IMPORTANT SAFETY RECALL

NHTSA Recalls No. 26V-167, 26E-016

| SAFETY NOTICE NHTSA: 26V-167 | SN-737 |

SUBJECT: *Pole Guide 450543 Plate Weldment*

Examples of cracks:

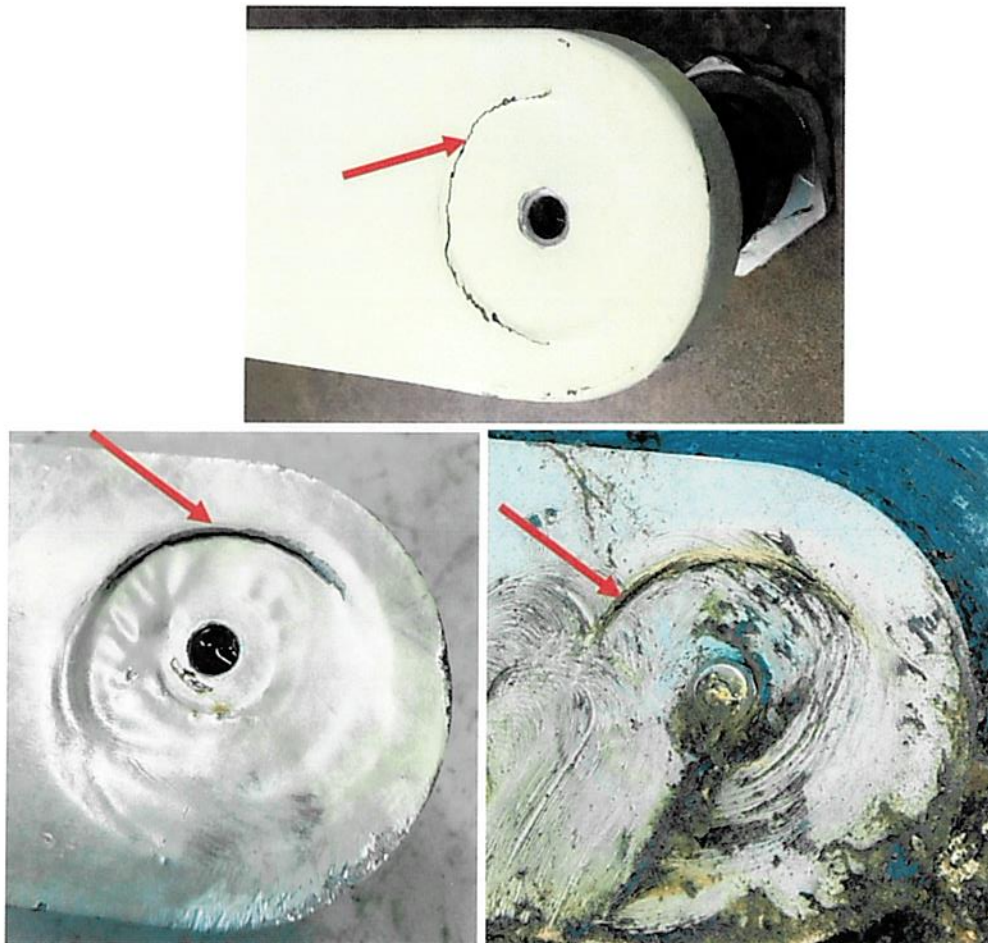
Affected Guide bars: (see Inspection Procedures below)

1. The top surface of the bar will have a grease zerk.
2. The grease zerk will be on the upper side above the pole guide arms not recessed.

Inspection procedure:

Affected Plate Weldment 450543, may be on machines which use these Pole Guide assemblies: 9143641, 618527, 608863, 494477, 491558, 488466, 483997, 481644, 479606, 479604, 469357, 464832, 463513, 458141, 479606HDG, 403186, or purchased as replacement parts.

Identify Guide Bar:

1. Inspect for cracked welds as shown in Inspection Procedure below. If cracks are found, do not use the pole guide. Contact Terex Utilities as noted below.
2. Inspect the digger derrick pole guide plate weldment 450543 using the criteria below for weldments subject to this bulletin.
